**City of Escondido
PRELIMINARY
PRIORITY DEVELOPMENT PROJECT (PDP) SWQMP**

**KING'S BARN
PL24-0091**

PDP SWQMP FOR KING'S BARN

This PDP SWQMP presents a revision to the March 29, 2024 report pursuant to the City of Escondido plan check comments received May 13, 2024. The following text identifies the plan check comments along with the responses in bold.

Attachment 1D

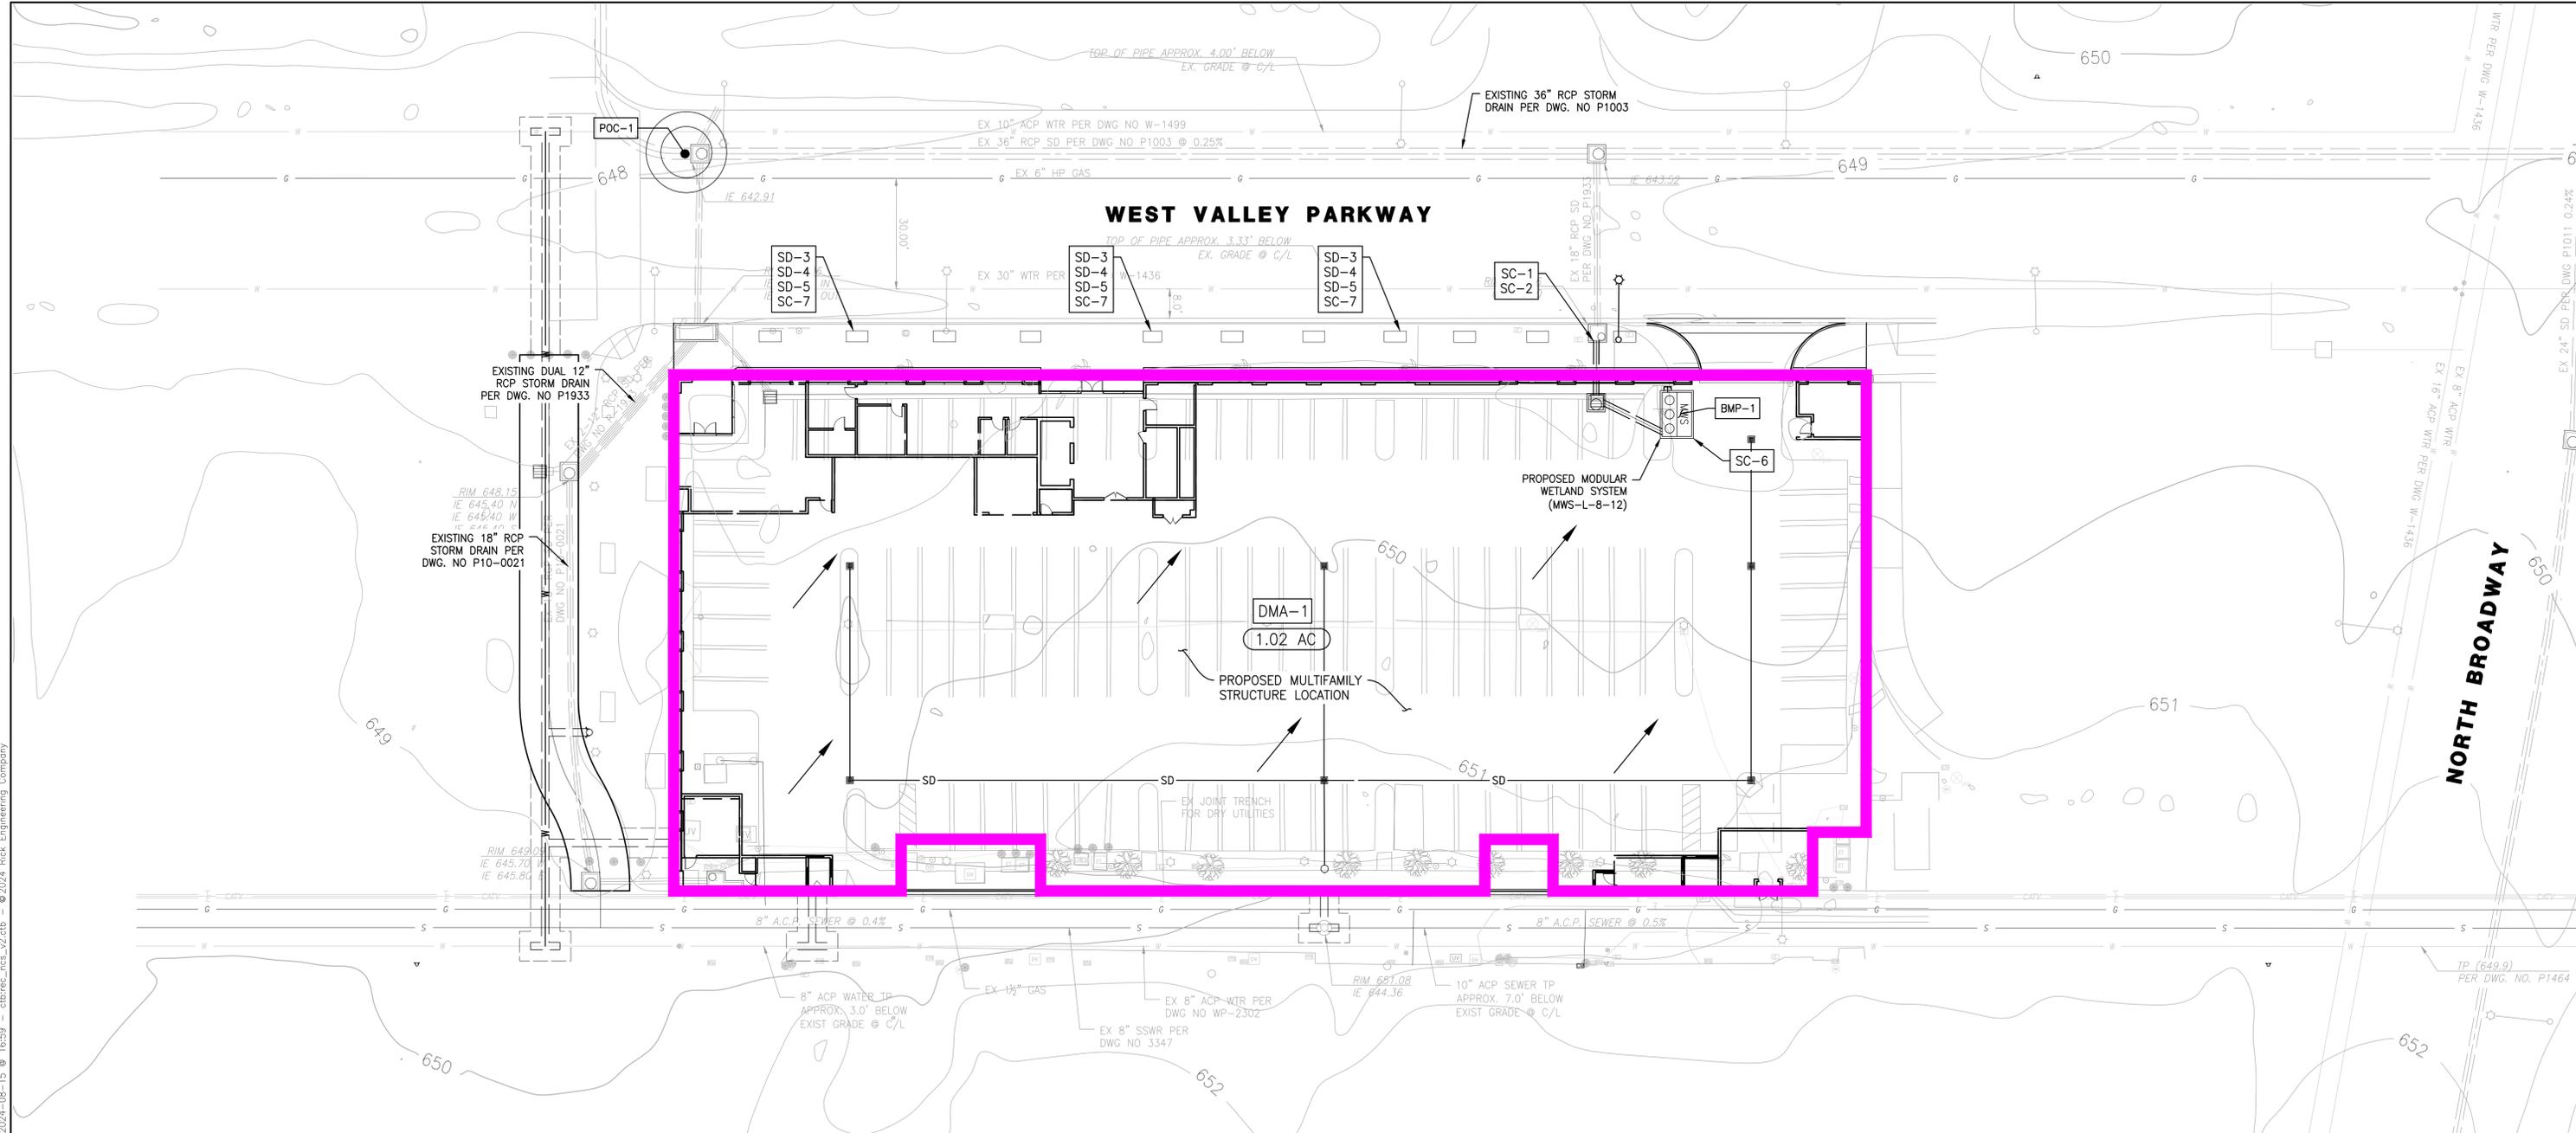
53. Flow Direction - Please provide flow direction arrows on the DMA exhibit.

Flow direction arrows added to DMA exhibit.
